FIELD CHANGE ORDER

Reference No. : FCO74000002
Date : March, 2003
Product Group : 740

**Tube assembly
ROT 350, ROT 351,
ROT 500, ROT 501,
ROT-GS 501, ROT 504,
ROT-GS 505, ROT 507**

Loose fixing screws on the supporting bridge of the tube housing of the tube assembly

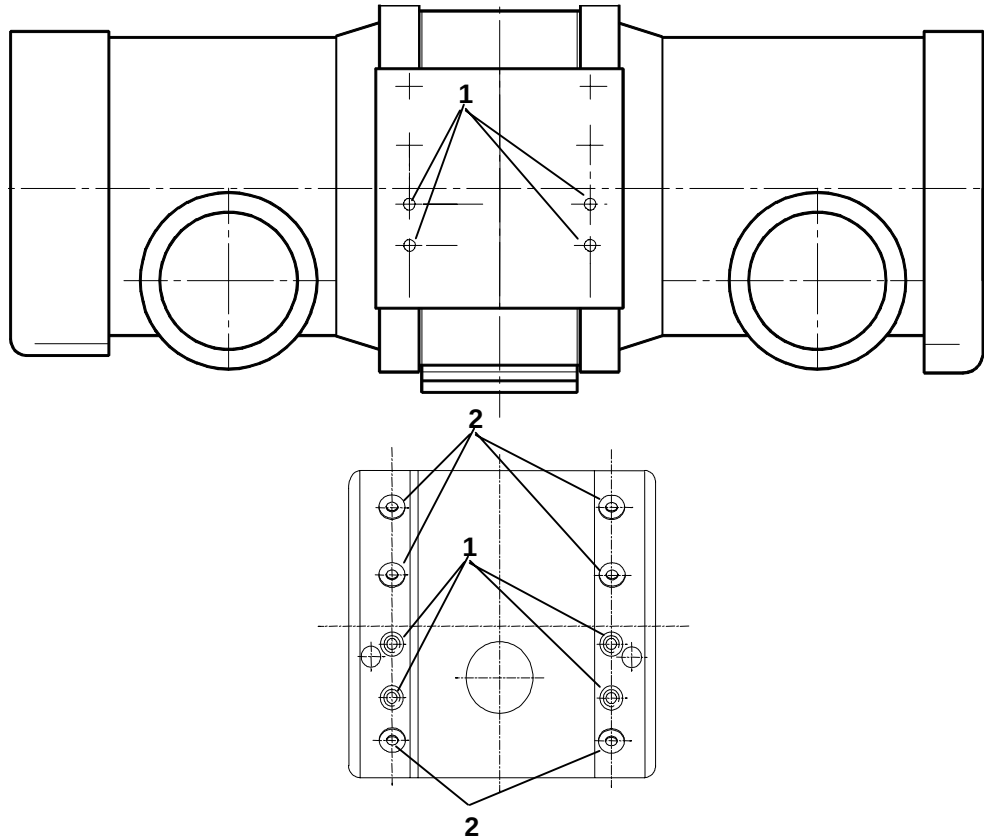
- Symptom** : Problems with the radiation geometry during operation of the tube assembly. The centering of the central beam does not coincide with the geometry of the imaging system (film or, respectively, image intensifier).
- Cause** : The tube assembly is centered with respect to the system via the supporting bridge of the tube housing. The required stability to keep the tube assembly in position with respect to the central beam is provided by especially specified fixing screws **(1)**. See sketch below:

- Remedy** : Complaints from the field and inspections of returned tube assemblies have revealed that sometimes the fixing screws of the supporting bridge of the tube housing were loose. It was also found out that unspecified lengths of screws were used in the field which caused damage of the tube housing.
- Check of whether the fixing screws are tight and, if necessary, retightening of the fixing screws at least once a year. This work can be carried out during regular maintenance or any other service action.
- To fix the retaining rings of the supporting bridge of the tube housing use six cheese-head screws **(2)** with hexagon socket and conical spring washers.

Code number screw M5 x 12: 2522 007 15036
Code number spring washer M5: 2512 767 06004

The supporting bridge of the tube housing is fixed at the system side with four screws M6 x __ **(1)** and spring washers. The length of the screws depends on the system. Observe the inserted screw length (7.3 mm).
